**CITY PLAN COMMISSION****THURSDAY, AUGUST 8, 2024****FILE NUMBER:** S234-163**SENIOR PLANNER:** Hema Sharma**LOCATION:** Shorecrest Drive, north of Harry Hines Boulevard**DATE FILED:** July 11, 2024**ZONING:** IR**CITY COUNCIL DISTRICT:** 2**SIZE OF REQUEST:** 5.22-acres**APPLICANT/OWNER:** Benajamin P. Ralston; Douglas R. Ralston; Denton Walker

**REQUEST:** An application replat a 5.22-acre tract of land containing all of Lot 1 in City Block A/5773 and a portion of a tract of land on City Block 5773 to create one lot on property located on Shorecrest Drive, east of Harry Hines Boulevard.

**STAFF RECOMMENDATION:** The request complies with the requirements of the IR Industrial/ Research District; therefore, staff recommends approval of the request subject to compliance with the following conditions:

OWNERS: DODD L. R. BAULTON AND L.P. MARGRIPPE, DENTON WALTER, DALLAS TEXAS  
 PREPARED BY: CBG CONSULTING & SURVEYING  
 222.457.82 SQ.FT. / 5.22 ACRES  
 LOT 18, BLOCK A/573,  
 SHORECREST ADDITION  
 CITY OF DALLAS, DALLAS COUNTY, TEXAS  
 CITY PLAN FILE NO. S234-163

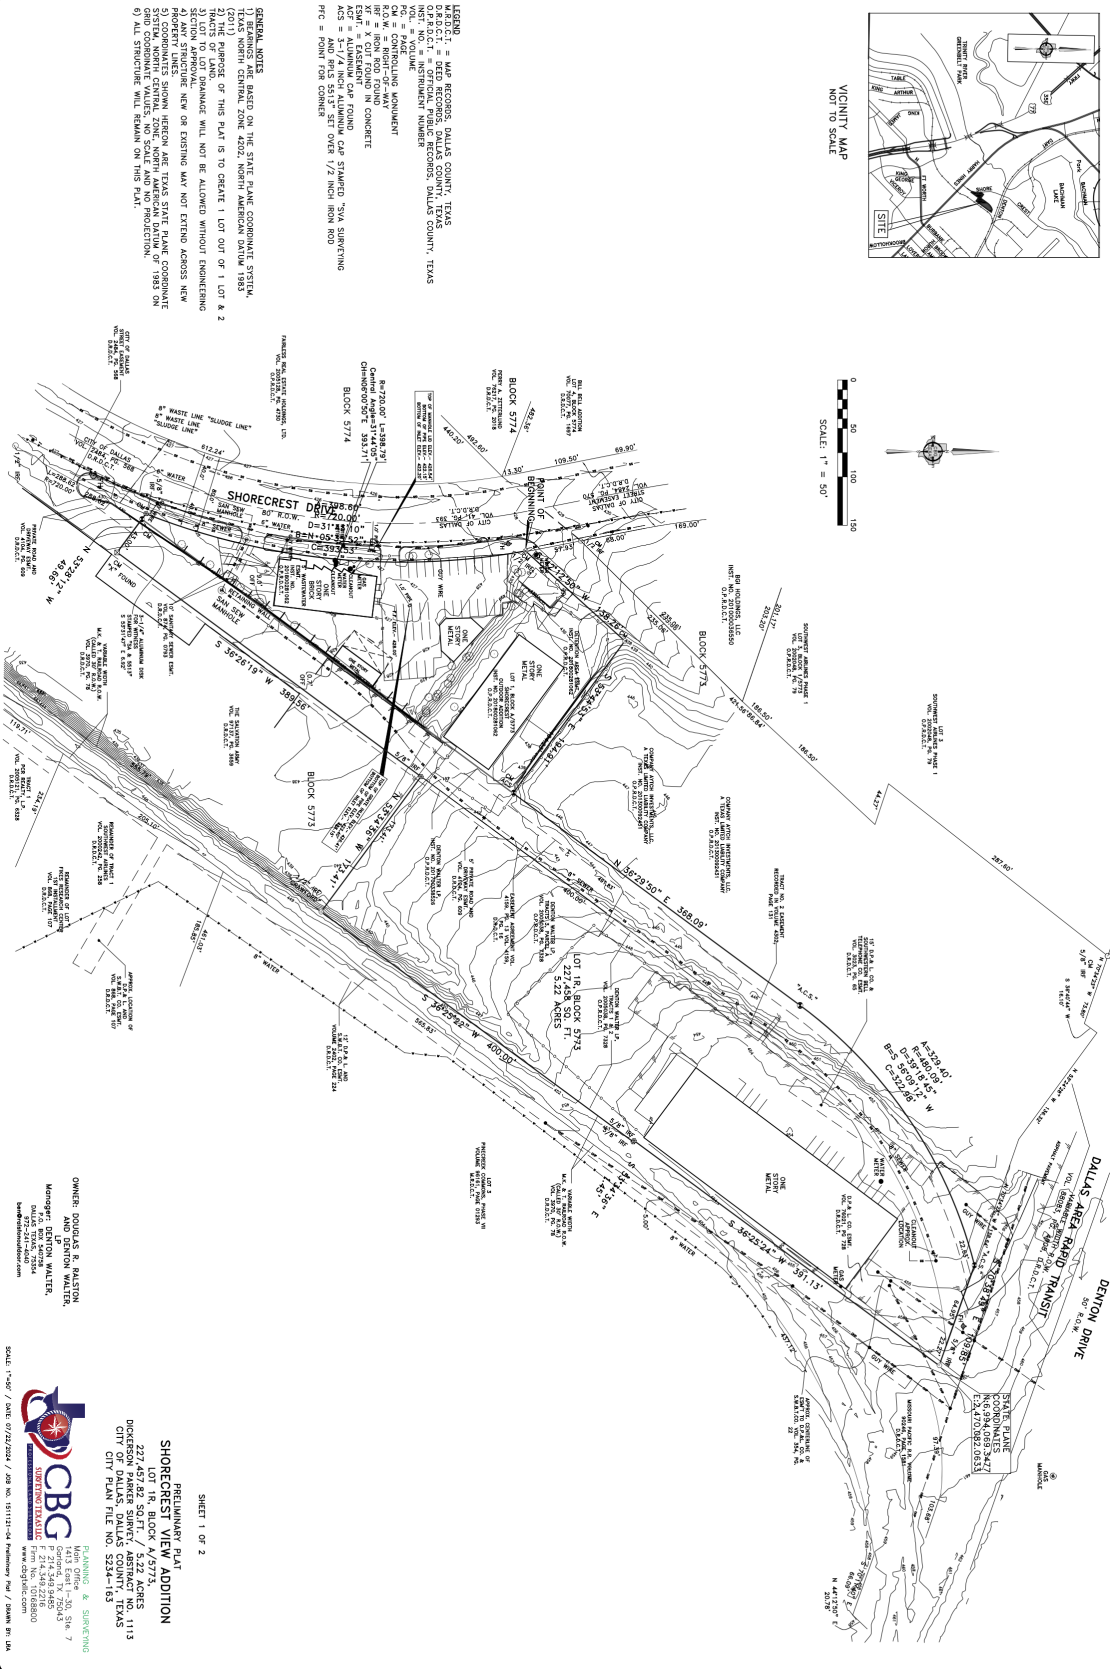
16. Prior to final plat, submit a completed final plat checklist and all supporting documents.
17. On the final plat, show how all adjoining right-of-way was created. Section 51A-8.403(a)(1)(A)(xxii).
18. On the final plat, show distances/width across all adjoining right-of-way. Platting Guidelines.
19. On the final plat, show recording information on all existing easements within 150 feet of the property.
20. On the final plat, show all additions or tracts of land within 150 feet of the property with recording information. Platting Guidelines.

21. On the final plat, show or list the prior plat on the map, in the legal description, and/or title block. Platting Guidelines.

22. Additional design information is required for assessment. Site plan must be submitted showing proposed development, building finished floor elevation, development, existing mains – including downstream manhole, and proposed water and wastewater service locations. Submit water/wastewater engineering plans to 320 E. Jefferson Blvd., Room 200, Attention: Water and Wastewater Engineering.
23. Water and Wastewater main improvements may be required by Private Development Contract. Submit water/wastewater engineering plans to 320 E. Jefferson Blvd., Room 200, Attention: Water and Wastewater Engineering.
24. Existing and any proposed Water and Wastewater Easements must be shown and/or increased to conform to current design standards. **Notice:** Minimum DWU easement size 20' for one utility and 25' for both water and sewer. Larger diameter or deeper mains may require additional width.

25. Prior to final plat, contact Real Estate to discuss remedy parking lot and fence encroachment to right of way along Shorecrest Drive.
26. On the final plat, identify the property as Lot 1A in City Block A/5773.
